Docket No. 52-021
MHI Ref: UAP-HF-09453

Subject: Amended MHI's Responses to NRC's Requests for Additional Information on Advanced Accumulator for US-APWR Topical Report MUAP-07001-P, Revision 2

**Amended MHI's Responses to NRC's Requests
for Additional Information**

**Advanced Accumulator for US-APWR Topical Report
MUAP-07001-P, Revision 2**

Fig. 33-1 Example of Distension of a Nitrogen Bubble due to Gas Expansion

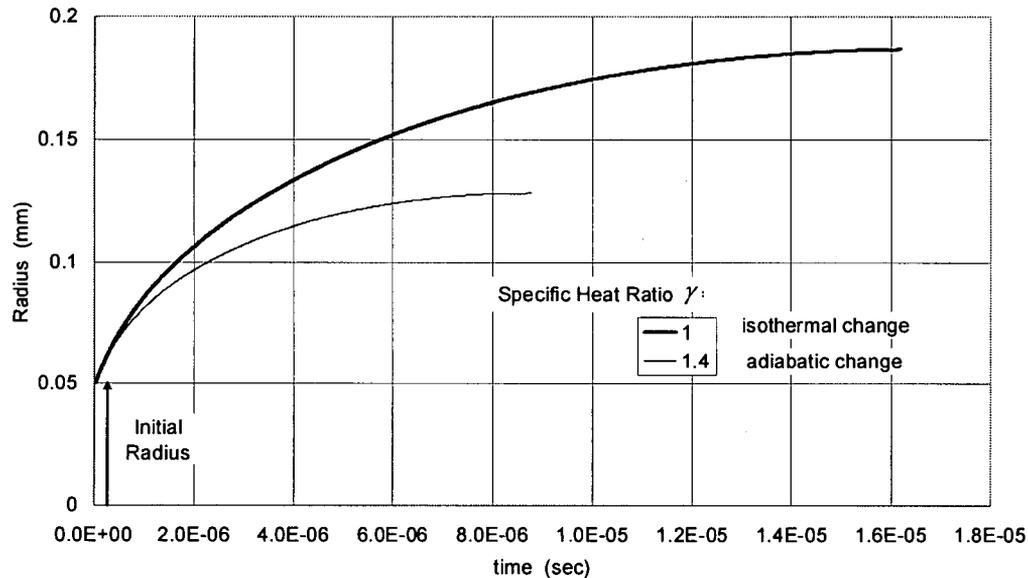
It will take time for accumulator to become saturated with nitrogen. The upper layer will saturate but thereafter, the dissolved gas will diffuse to the rest of the accumulator liquid. If there are any convection currents in the liquid, the mixing will be even faster. The response to RAI 5b dated September 2008, regarding the dissolved ratio of nitrogen in terms of diffusion period of 2 years through 10 years, does provide the actual concentration of the dissolved gas, and the dissolution of the gas as the fluid particles move to the lower pressure. The amount of gas that will evolve depends on the nucleation sites and interfacial area.

Why are the effects of nucleation sites, interfacial area density and convection not addressed, in addition to the diffusion process?

The pressure drop in the actual accumulator tank is slow. However, let's consider a nitrogen bubble that experiences abrupt depression from the storage pressure of 5.33MPa to an atmospheric pressure of 0.101MPa at time $t=0$ sec as a stepwise to be able to examine the growth of the bubble as the most conservative. The bubble at first rapidly expands due to gas expansion, then nitrogen slowly permeates in water due to diffusion of saturated nitrogen. Bubble dynamics due to gas expansion in inviscid fluid is given by the following equation (L.D. Landau and E.M. Lifshitz: Fluid Mechanics, Pergamon Press, 1975):

The distension of a spherical bubble with an initial radius 2×10^{-3} in (0.05mm) due to gas expansion is shown in Figure 33-1. Surface tension on the bubble was taken into account in the calculation. Bubble distension due to gas expansion is very rapid. For adiabatic change, or

specific heat ratio $\gamma=1.4$, the bubble is distended in 9×10^{-6} sec, and for isothermal change, or $\gamma=1.0$, the bubble is distended in 1.6×10^{-5} sec. An actual bubble will be abruptly distended in time between them.

Figure 34-1 Accumulator flow rate during Large Break LOCA

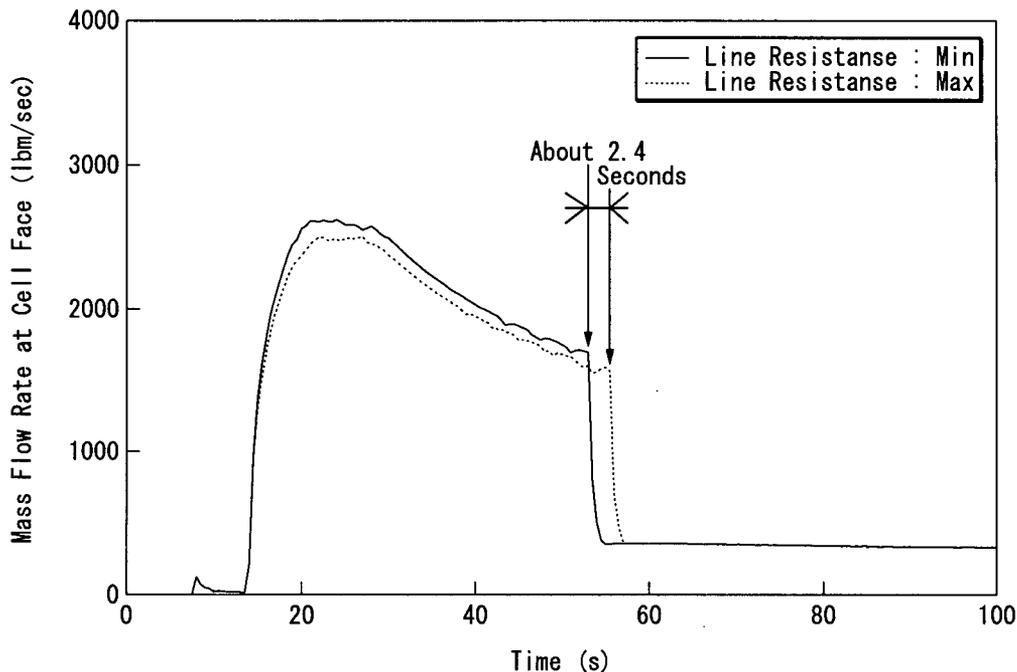
How is the effect of nitrogen accounted for in implementing accumulator characteristic equations? Is there any delay in accumulator flow to account for nitrogen effect? How is this delay estimated? How is this delay validated to full scale accumulator?

(c) In Large Break LOCA analysis, the accumulator injection line piping resistance uncertainty is treated as a statistical parameter, and the resistance which is sampled randomly from uniform distribution within the range of $\pm 10\%$ is used for the analysis. For the cases with maximum and minimum piping resistance, duration of large flow injection period is different by approximately 2.4 seconds (Figure 34-1). Therefore, the large flow injection completion time delay induced by the effect of nitrogen is bounded by considering piping resistance uncertainty.

As above description, 2.4 seconds of large flow injection completion time delay considering piping resistance uncertainty encompasses 2 seconds of delay in full height 1/2 scale test case 5. The large flow injection completion time delay in test case 5 is expected to be applicable to full-scale accumulator for the following reasons:

- Since the Full-height 1/2 scale model is used in the actual pressure condition, time axis of injection characteristic (time vs. injection flow rate) is the same in the test model and actual accumulator. Therefore, with the initial tank pressure and back pressure equivalent to the actual condition, the injection time of test and actual accumulator will be the same.

- The large flow injection completion time delay in test case 5 is assumed to be induced by expansion of microbubbles formed by compulsory bubbling and showering before the test initiation by depressurization, which decreased effective density of water and increased pressure drop in the flow damper and injection pipe. Since bubbles grow very fast according to pressure change as described in the response to RAI 33, decrease of effective density of water does not depend on the scale of accumulator tank and flow damper if the amount of microbubbles in the tank water and tank pressure are the same. It is very conservative to consider large flow injection completion time delay which is comparable with the delay time in the test case 5 as the worst case in safety evaluation because the initial pressure of test case 5 is equal to the pressure in the actual ECCS performance analysis, and microbubbles more than test case 5 do not exist in the actual accumulator since compulsory bubbling and showering is not conducted.
